# ADDENDUM NO. 01

**Project Name:** TFSD Morningside HVAC Replacement

**Date Issued:** February 5, 2025

**1 ROOF FRAMING PLAN**  
S2.01 1/16\"/>

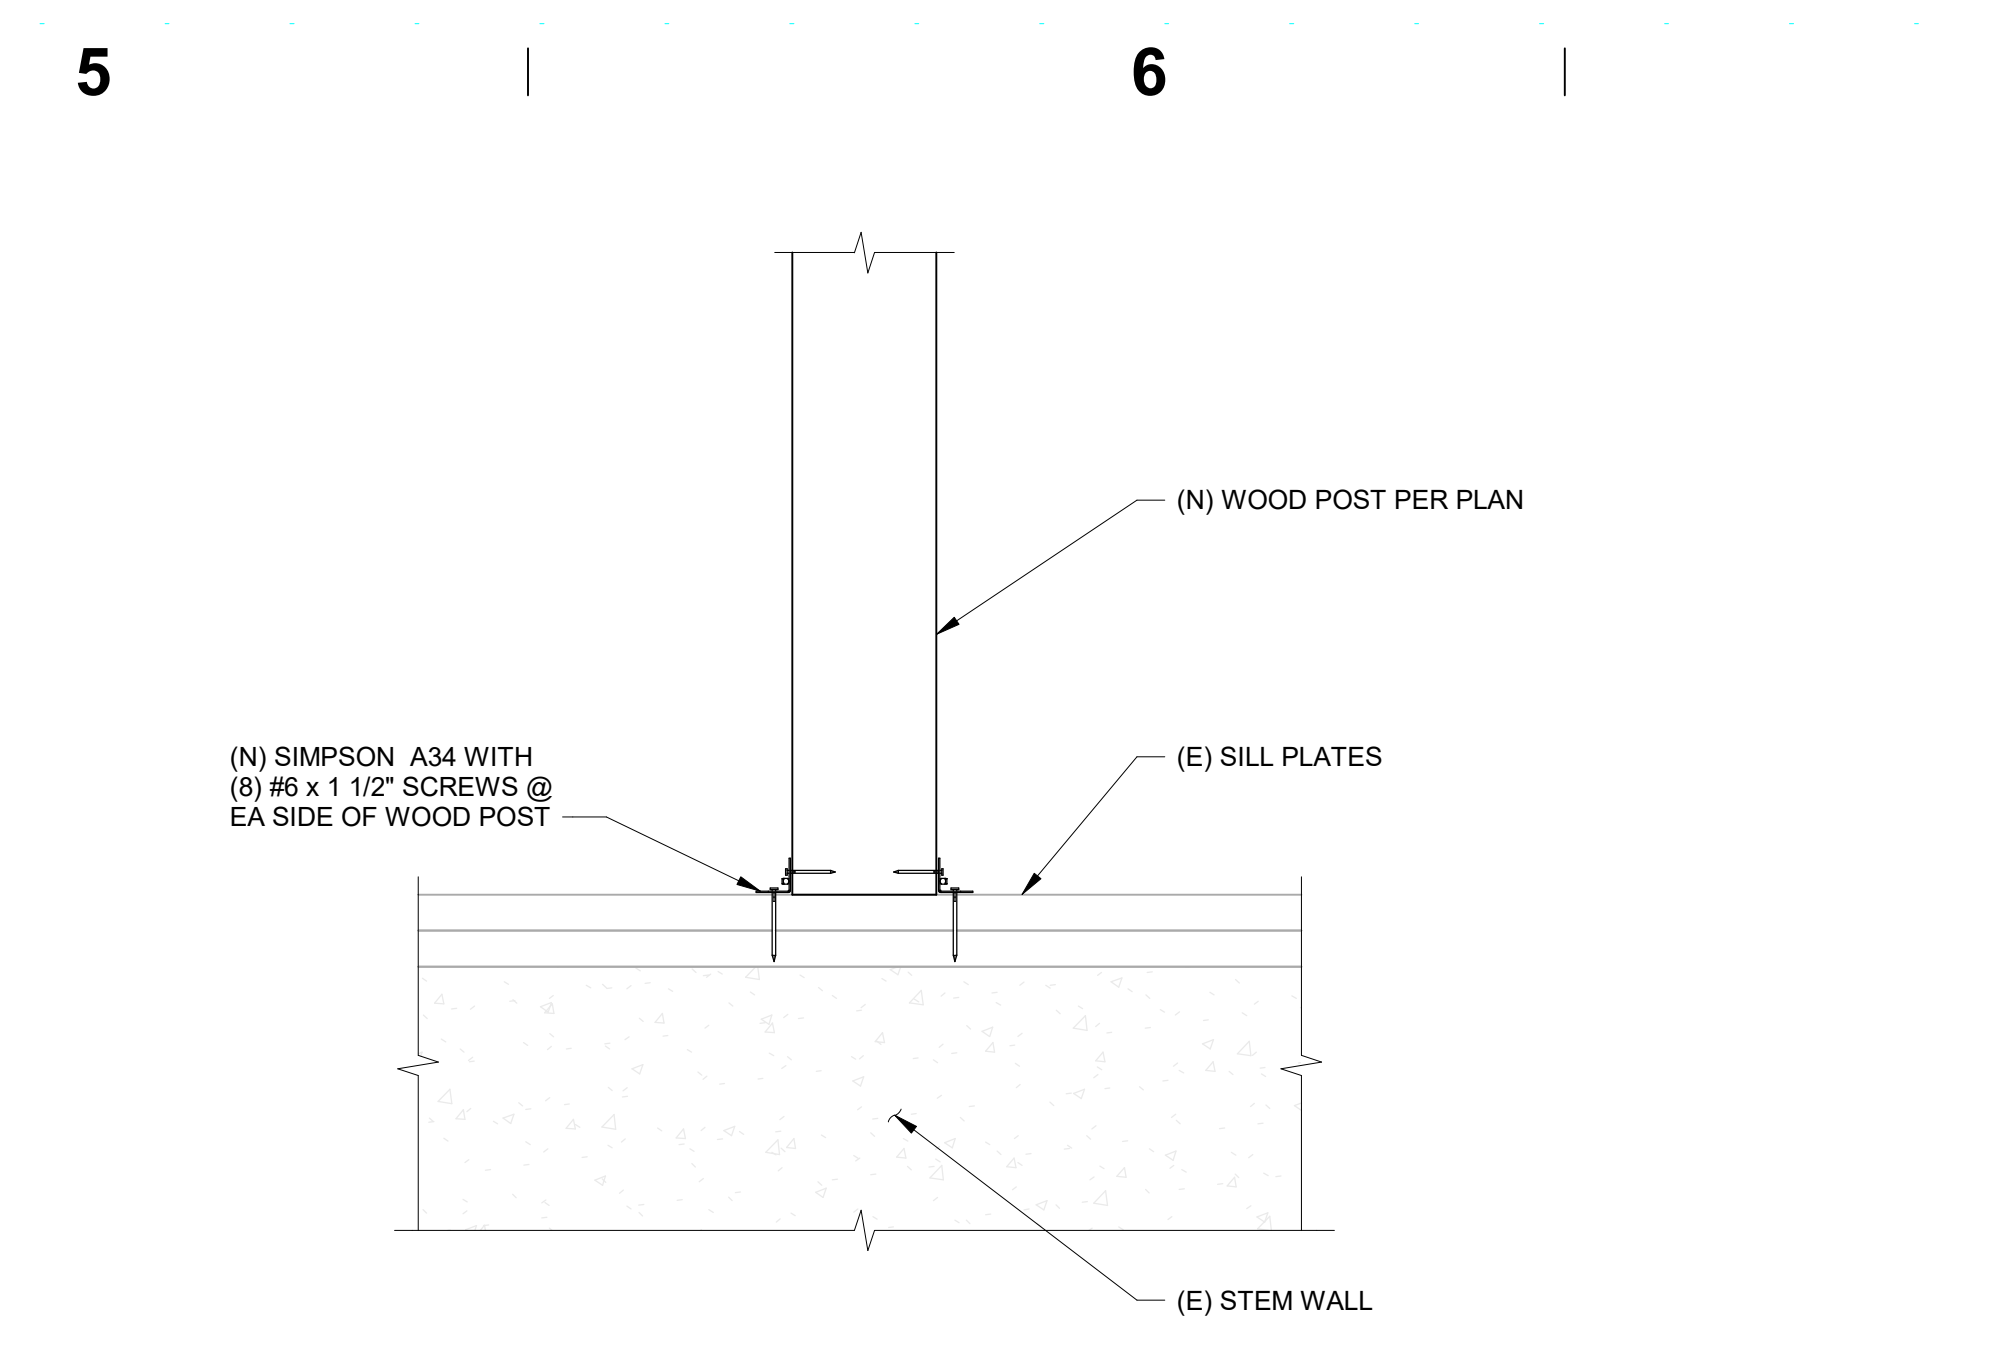
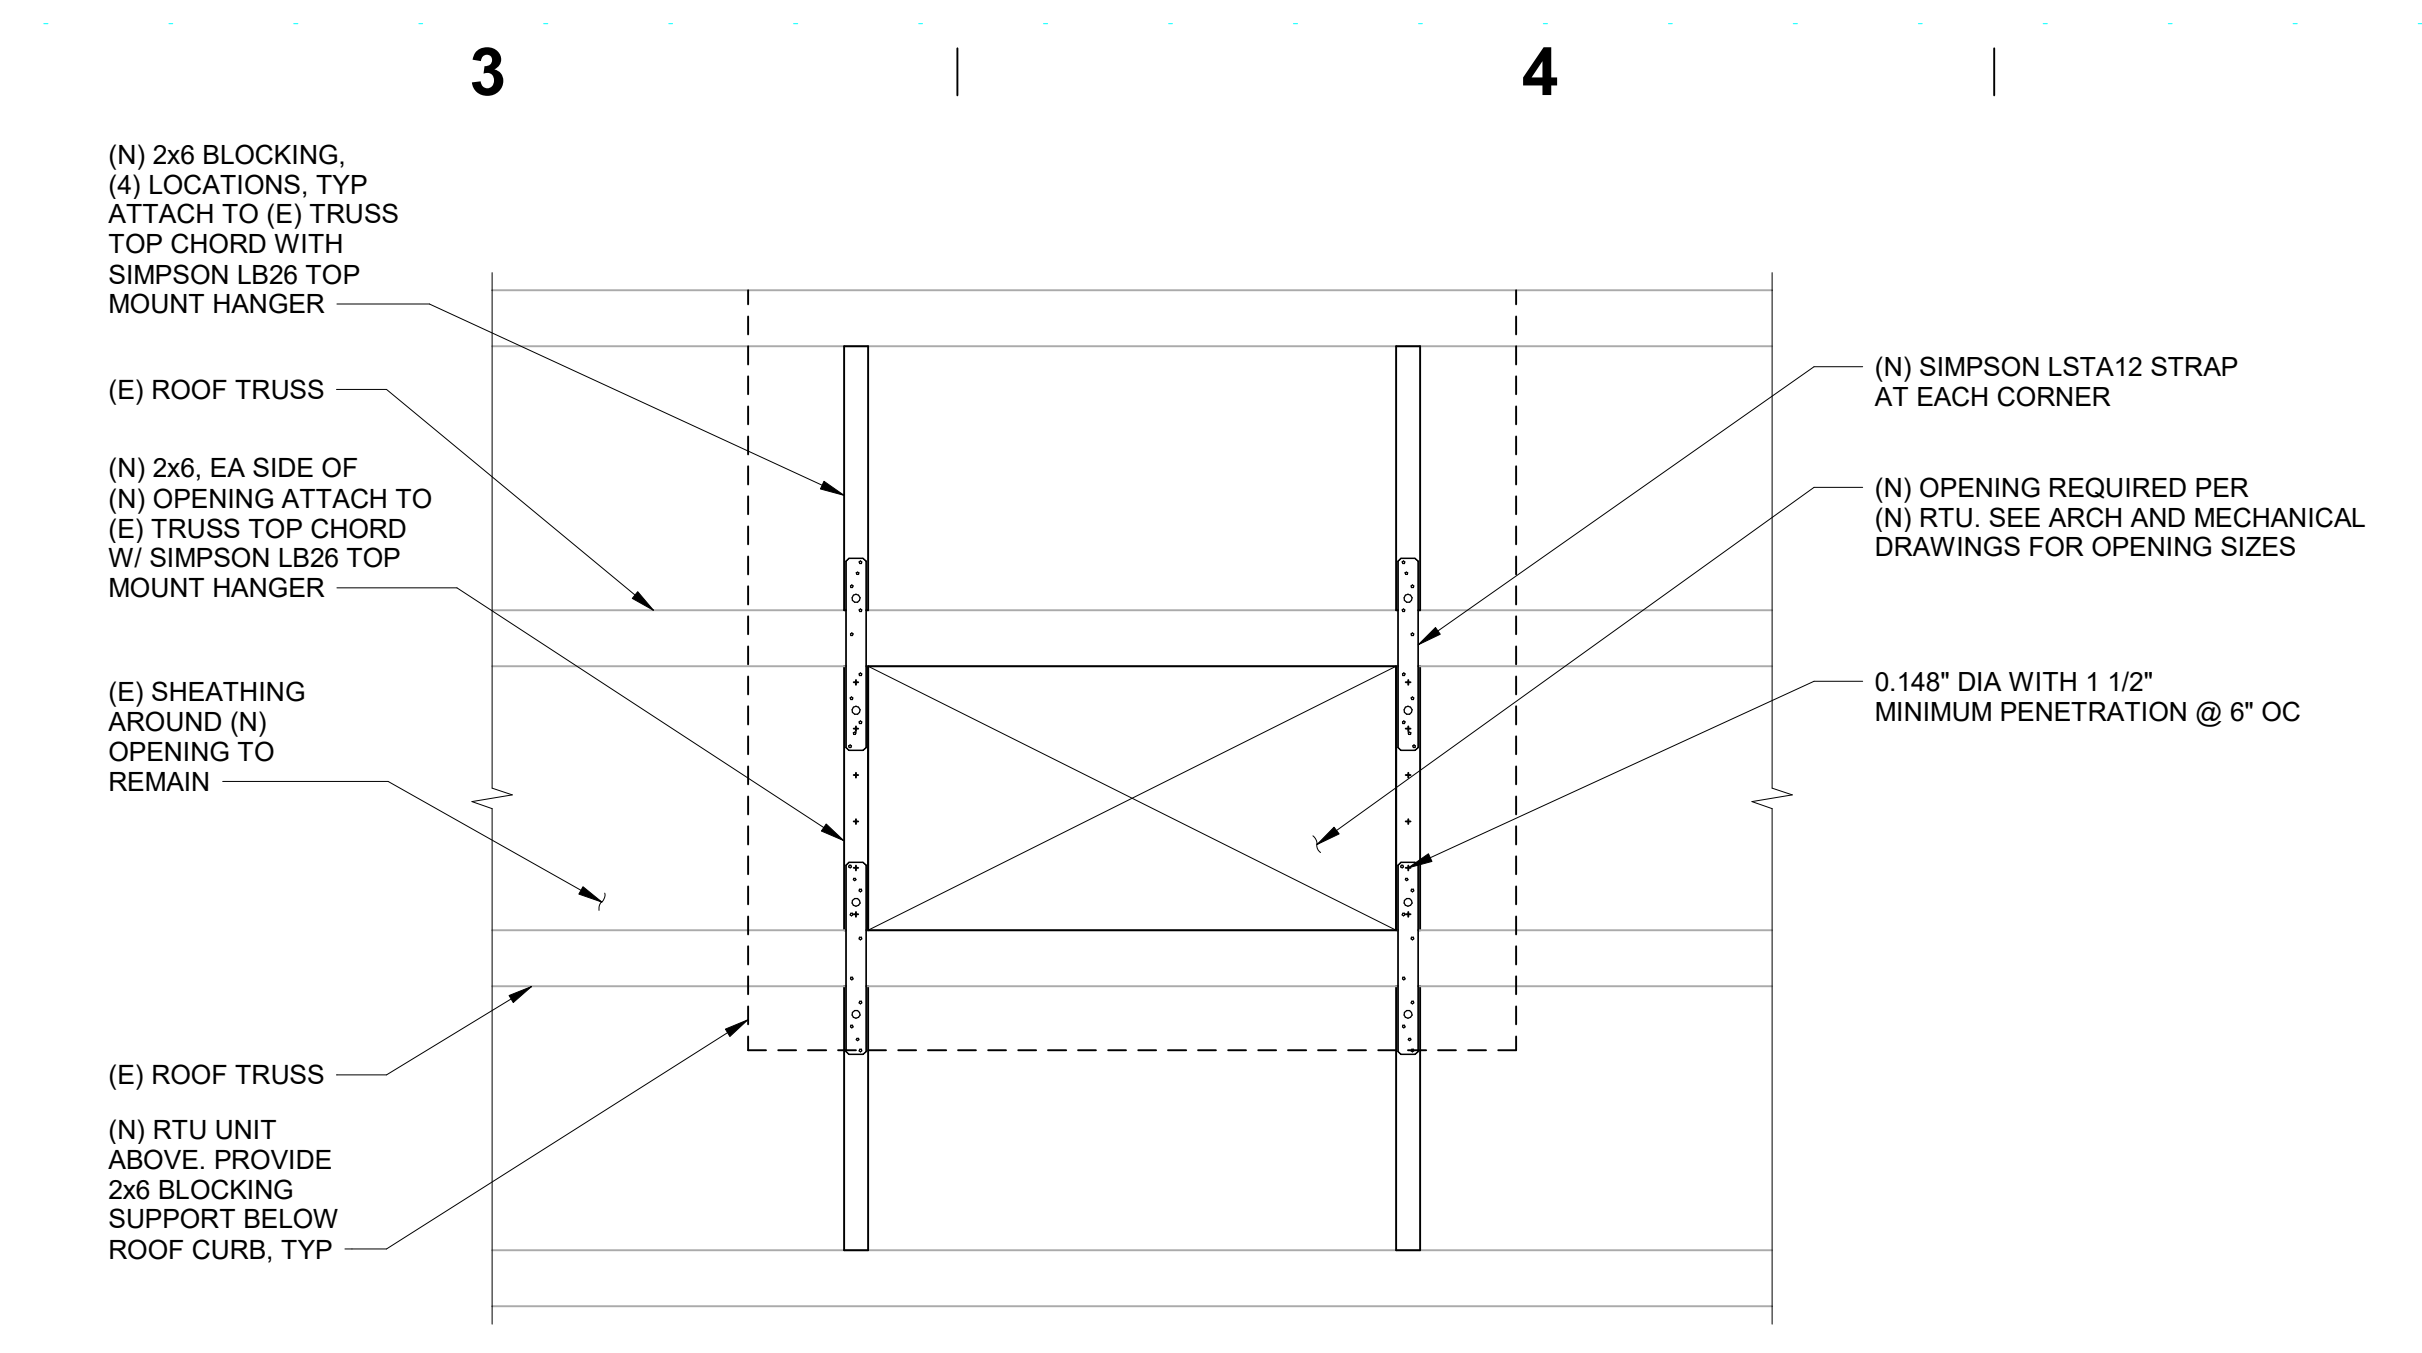
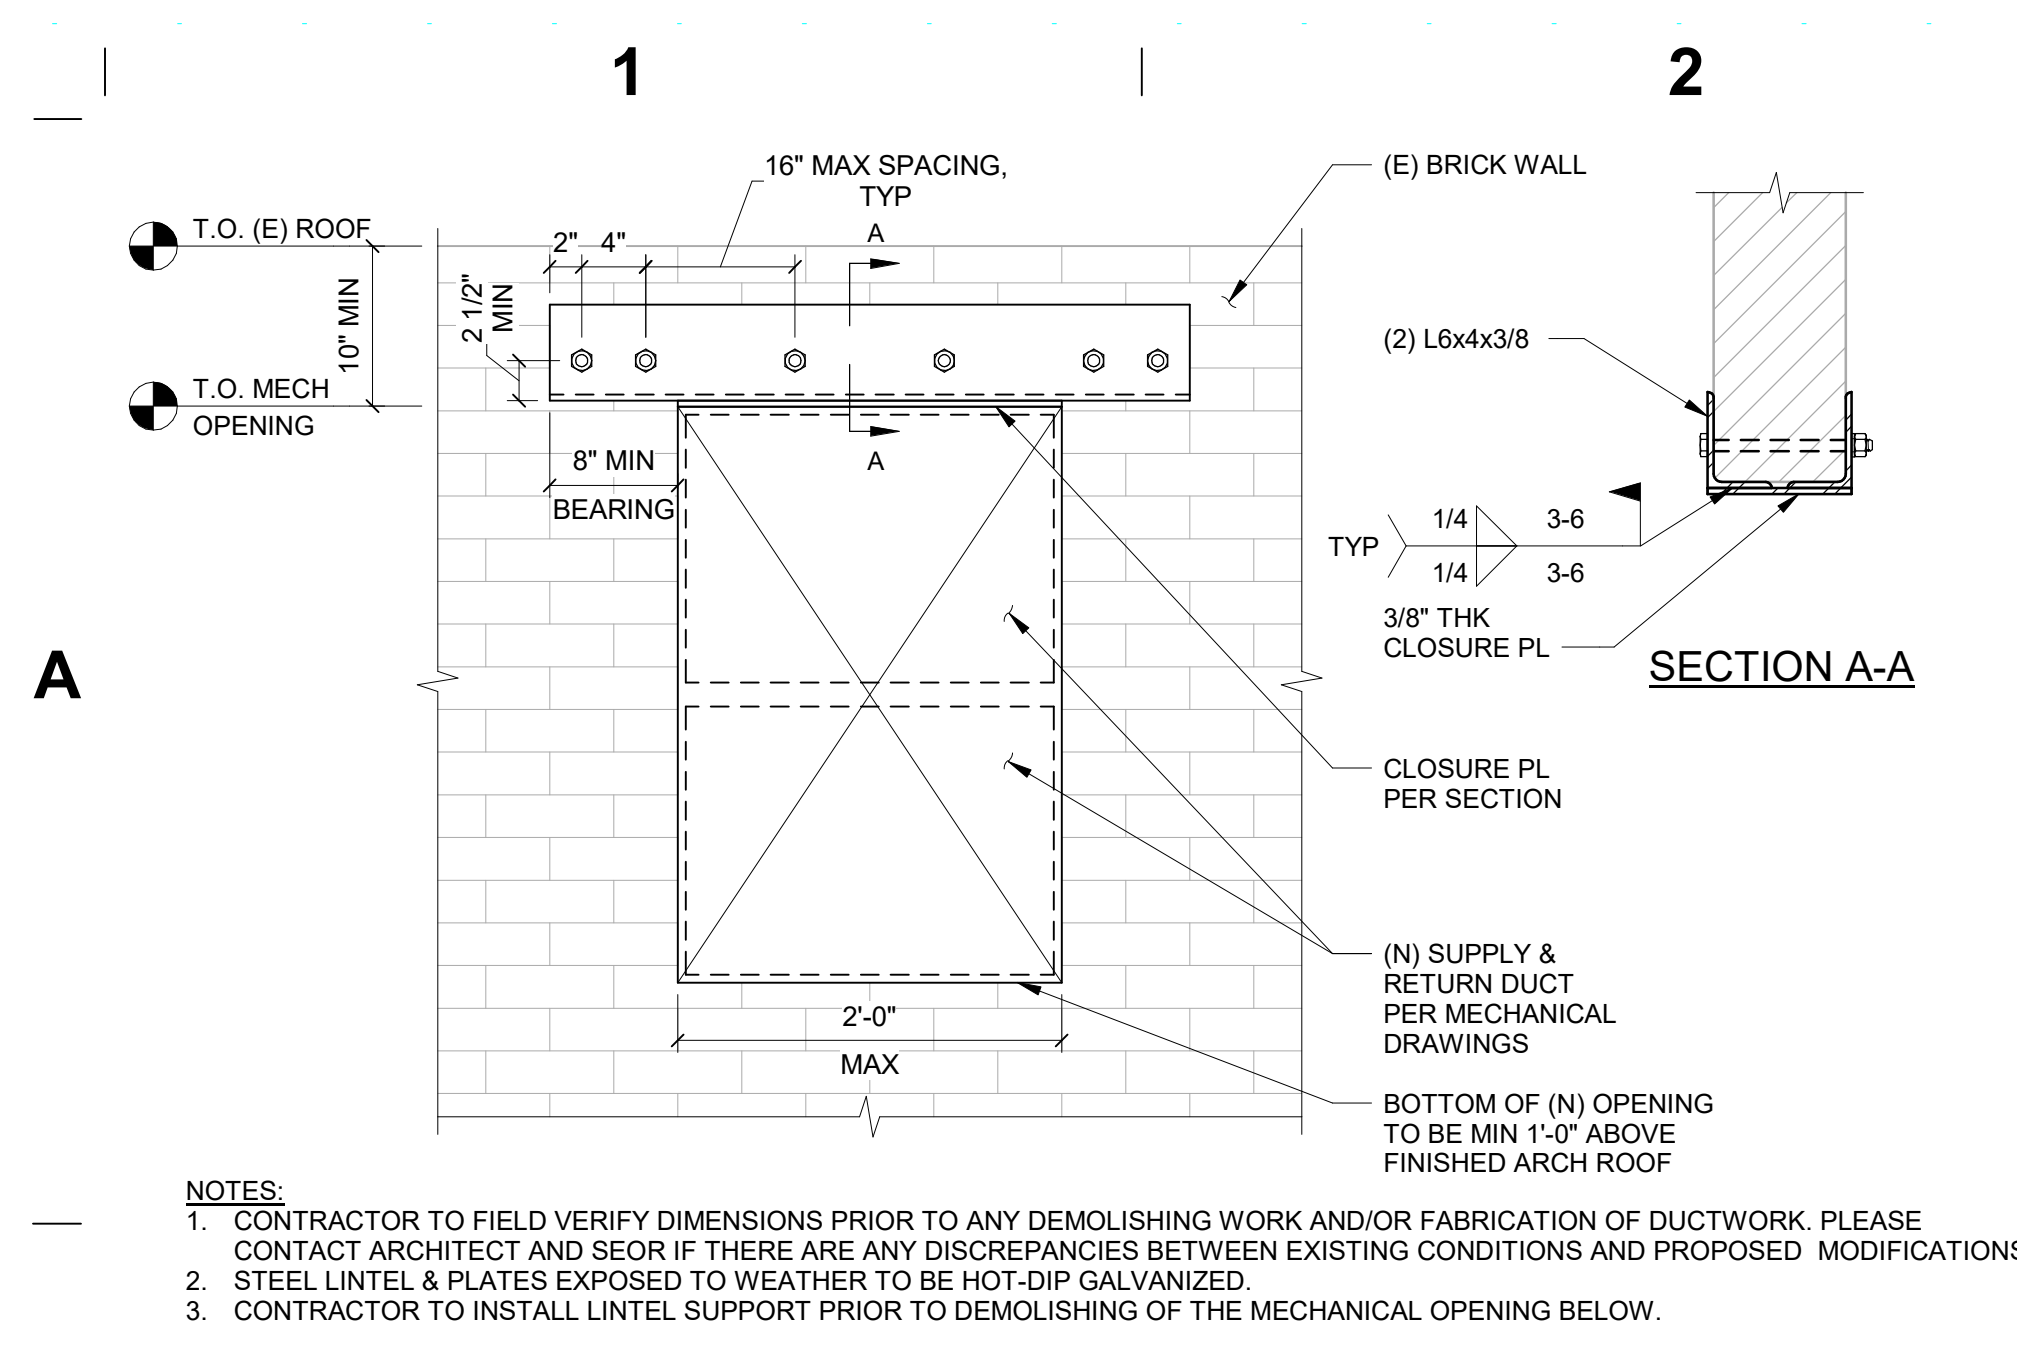
1. Roof tie anchor location shown on drawings near grid 1.2 & C.5. New 6x10 support beam was added to support tie anchor, along with 4x blocking and strapping. Key-note 24 was added to the drawings.

22	0.148\"/>
23	(N) MECH OPENING IN (E) STUD WALL PER DETAIL 4/S3.02.
24	(N) HARDY SADDLE TYPE ROOF TIE ANCHOR, (PART # - HTB-S24) CAPABLE TO RESIST MIN 5000 LBS LRFD LOAD IN ANY DIRECTION PER OSHA REQUIREMENTS. ANCHOR TO BE CENTERED BETWEEN (E) 2x JOISTS, PROVIDE (N) 6x10 BEAM BELOW TIE ANCHOR. CONTRACTOR TO FIELD VERIFY & LOCATE. SEE DETAIL 8/S3.02.
